INITIAL FIRE SAFETY INSPECTION REPORT

Pioneer Denim Limited (Garments Division)

RSC ID: 24833

Date: 04-Jan-2024

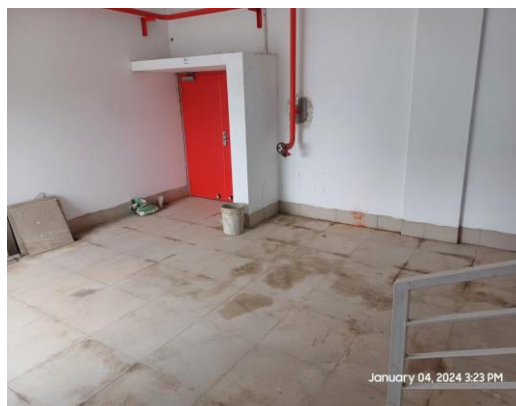
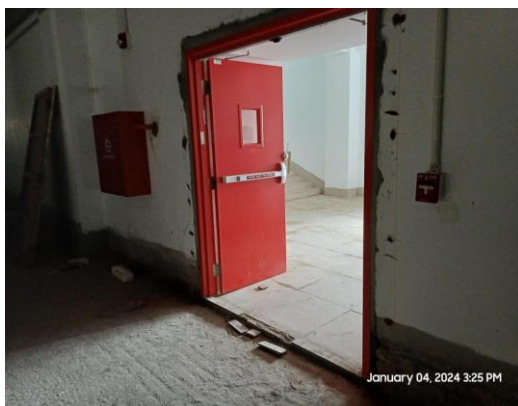
SI No.	Category	Findings	Required Action	Remediation Time Frame
F-1	Fire Rated Construction	The exit stairs are not separated from work areas, other spaces on each floor by fire-rated construction. Location: B#1: Building-6, R&D Building (6-Storied)	Provide minimum 2-hr fire rated construction for buildings 4 storied or more and 1-hr for up to 3 storied. Seal all unprotected openings to separate the exit stairs from work areas and other spaces on all floor levels by 90 minutes for 2 hr. construction and 60 minutes for 1-hr construction. Ensure that the fire rated doors are self-closing and positive latching and that they are provided with fire exit (panic) hardware where serving production floors. If fire rated doors are required to be held open for functional reasons, provide automatic closing devices tied to the fire alarm system.	Within 3 months

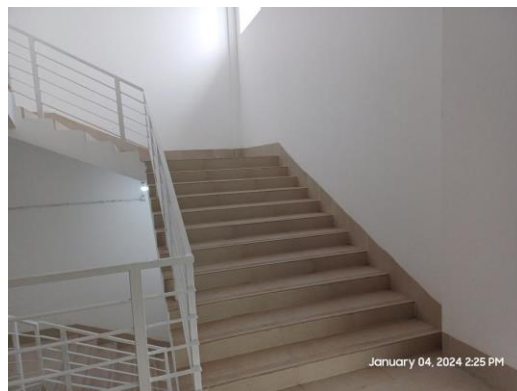
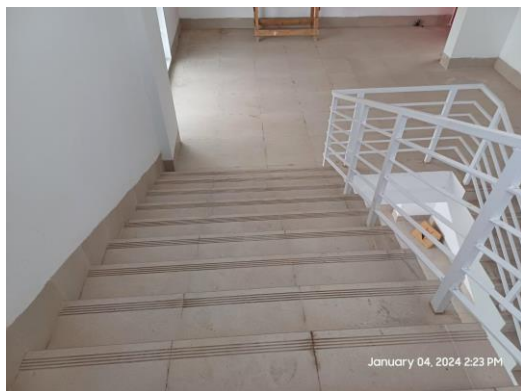
F-7	Fire Rated Construction	Exterior exit stair (North side of Gate Building-01) is not properly separated from the building and stair exit discharge The exterior stair on the North side of Gate Building-01 was not fire rated separation from the R&D Building (Building-6 (6-Storeyed) & transformer room (Ground floor of R&D Building)).	Exterior exit stairs shall be separated from the building with a rating requirement of 2 hr fire rating. The rating of the exterior wall shall extend 3.05 m (10 ft) beyond the ends of the stair structure	Within 3 months
-----	-------------------------	---	---	-----------------

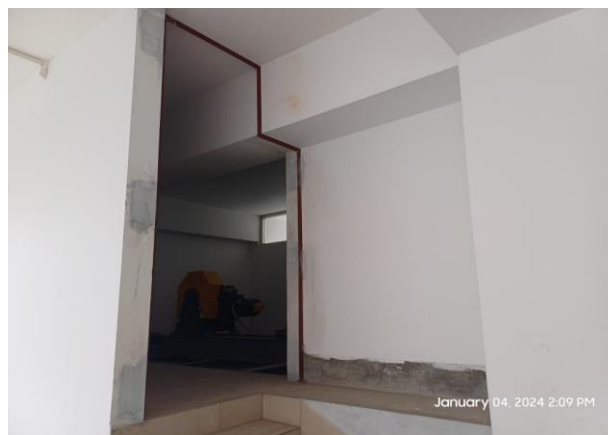
F-12	Means of Egress	Aisles marking has not been provided on the floor properly. Location: B#1: Building-6, R&D Building (6-Storied)	Provide minimum aisle widths of 36-in.	Within 3 months
------	-----------------	--	--	-----------------
